# MC68340

## ADDENDUM TO

# MC68340 Integrated Processor With DMA User's Manual - Rev 1

December 8, 1994

## **16. Internal IMB Arbitration**

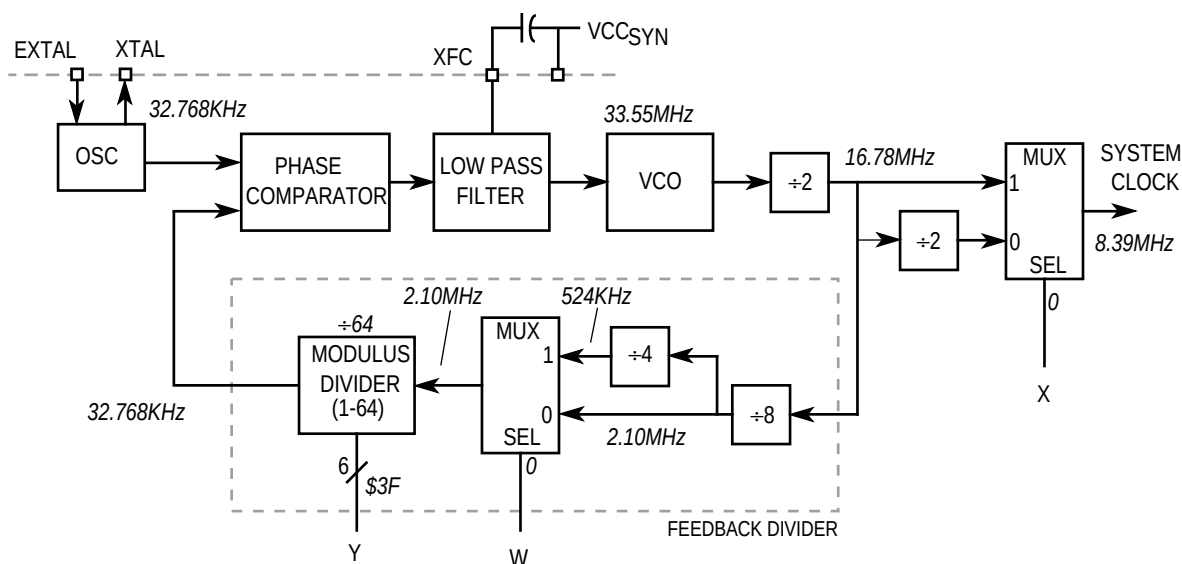
On page 4-6, first paragraph, change the first sentence to read "There are eight arbitration levels for the various bus masters on the MC68340 to access the inter-module bus (IMB)."

Figure 10-2. Sample Crystal Circuit

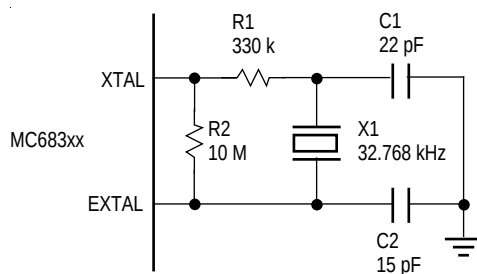
On page 10-2, Figure 10-2, the component values shown in the example 32KHz oscillator circuit may not provide enough loop gain for all crystals. For a more generally robust oscillator circuit, change C1 and C2 as shown below. A 10M resistor can be substituted for the 20M R2 bias resistor as shown.

Figure 10-3. SRAM Interface

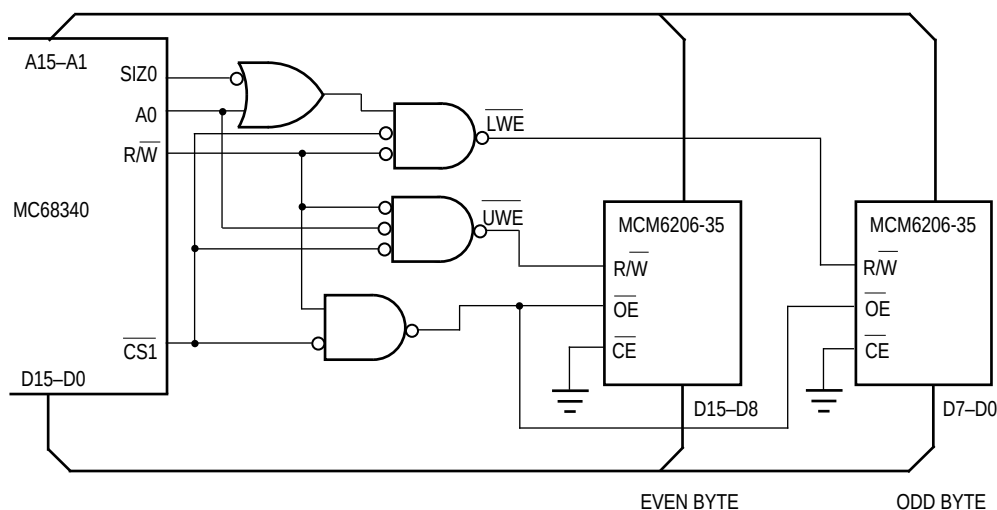
The SRAM interface shown in Figure 10-5, page 10-3 is incorrect - see the corrected drawing below.

**Figure 10-14. Circuit For Interfacing 8-Bit Device to 16-Bit Memory in Single-Address DMA Mode**

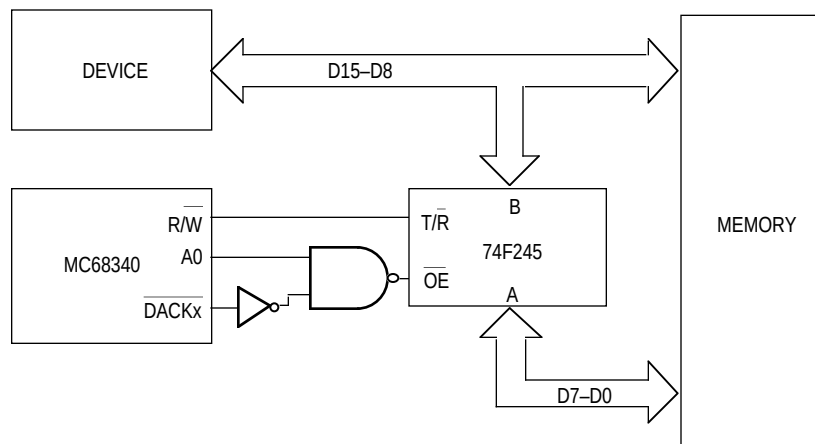
On page 10-10, the logic driving  $\overline{OE}$  on the 74F245 in Figure 10-14 should be corrected as shown below. Although not detailed, the byte enables for the memory block should be controlled during reads to prevent contention between the upper and lower bytes of the data bus when D7-D0 is muxed to the upper data byte.

## 71. TxRDY/RxRDY Pin Swap

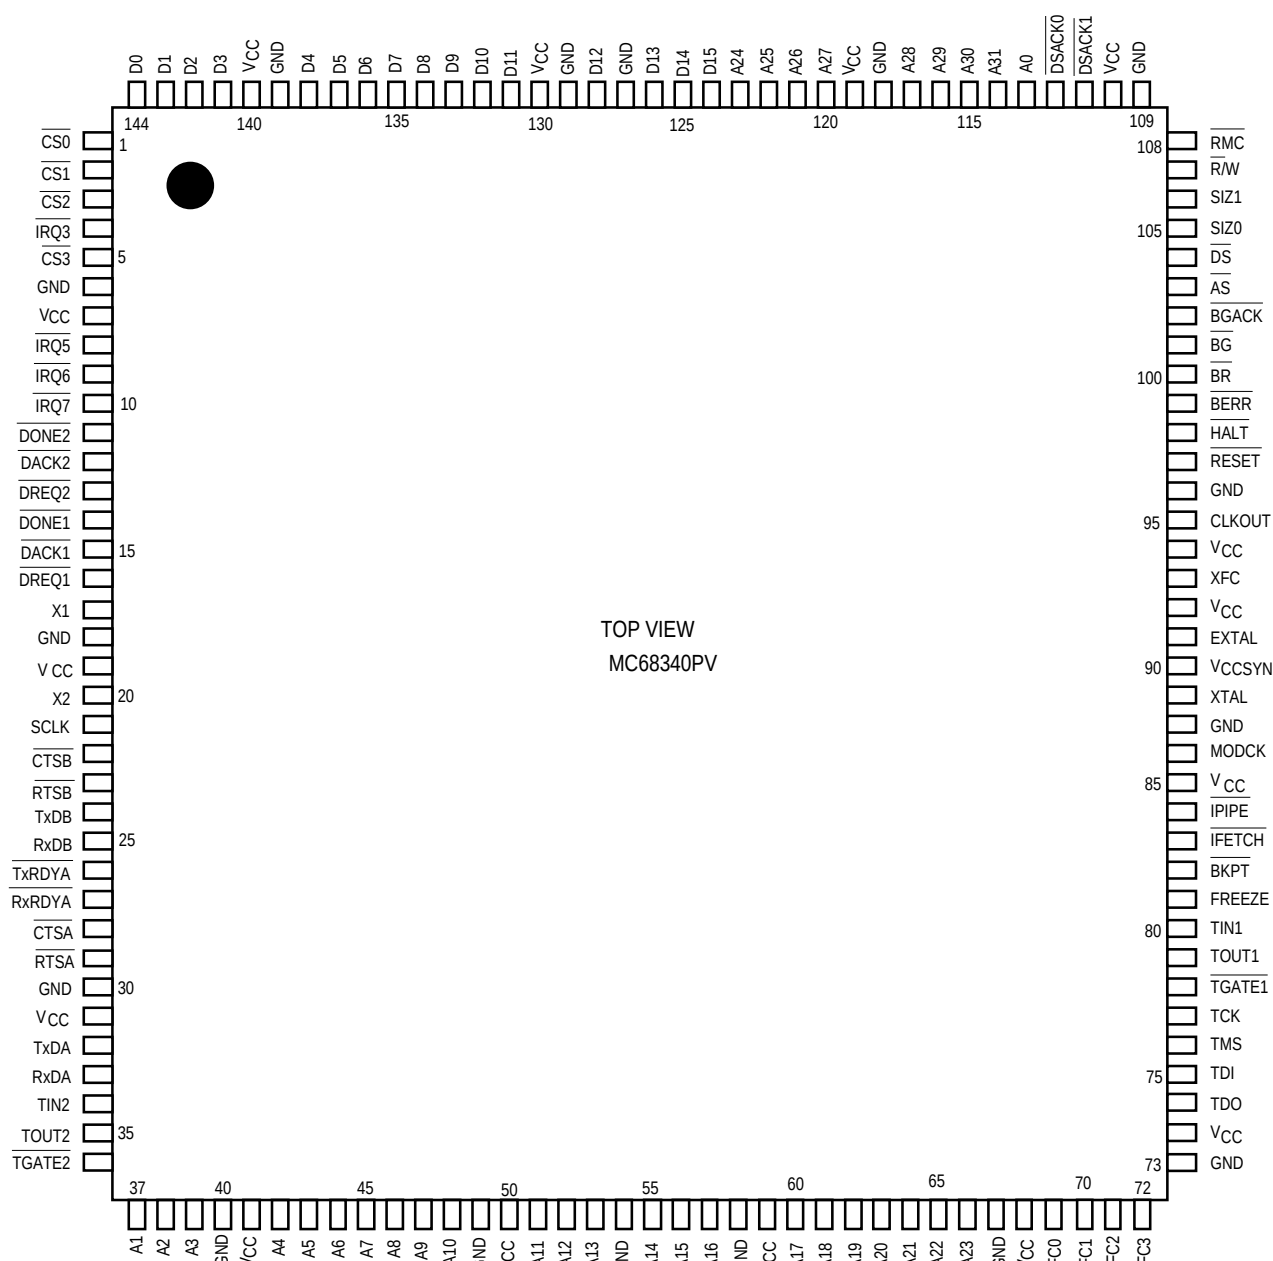
Add to the Pin Assignment section beginning page 12-2: Early documentation for the 68340, including the MC68340UM/AD Rev. 0 User's Manual, showed TxRDY and RxRDY swapped. The MC68340UM Rev. 1 documentation correctly shows the pinout of the CQFP with RxRDY on pin 82 and TxRDY on pin 83, and the PPGA package with RxRDY on pin B5 and TxRDY on pin A4.

144-Lead Thin QUAD Flat Pack (PV Suffix).

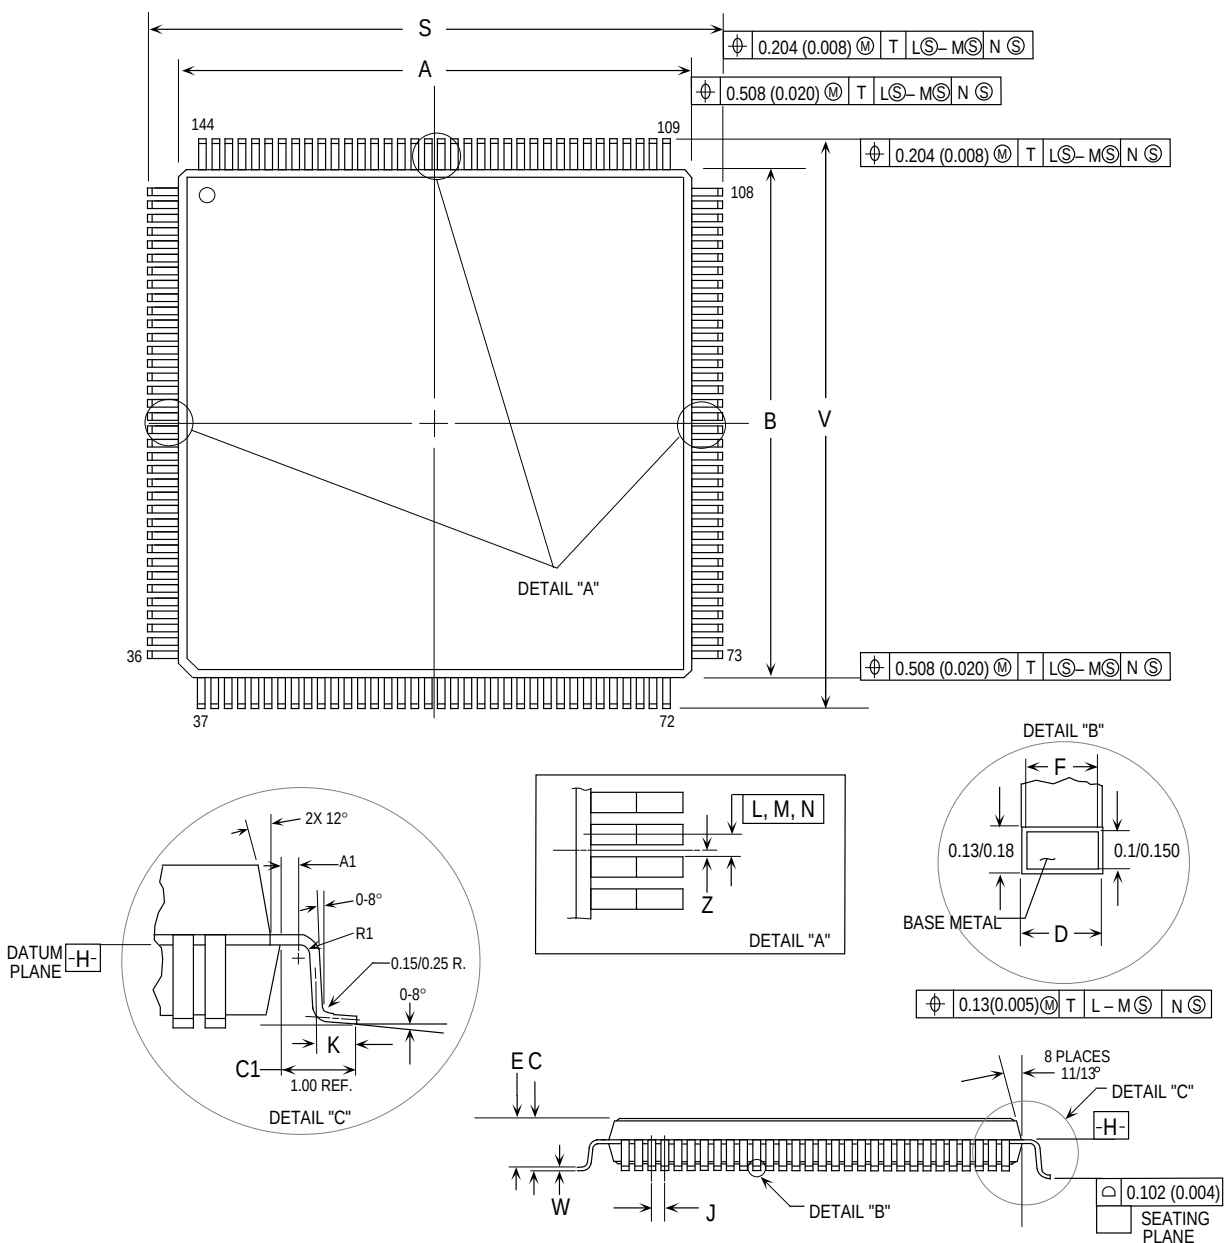
Note, the TQFP package pinout is a mirror image of the CQFP package (die is flipped). Pinout and mechanical information for the TQFP package are shown on the following pages.
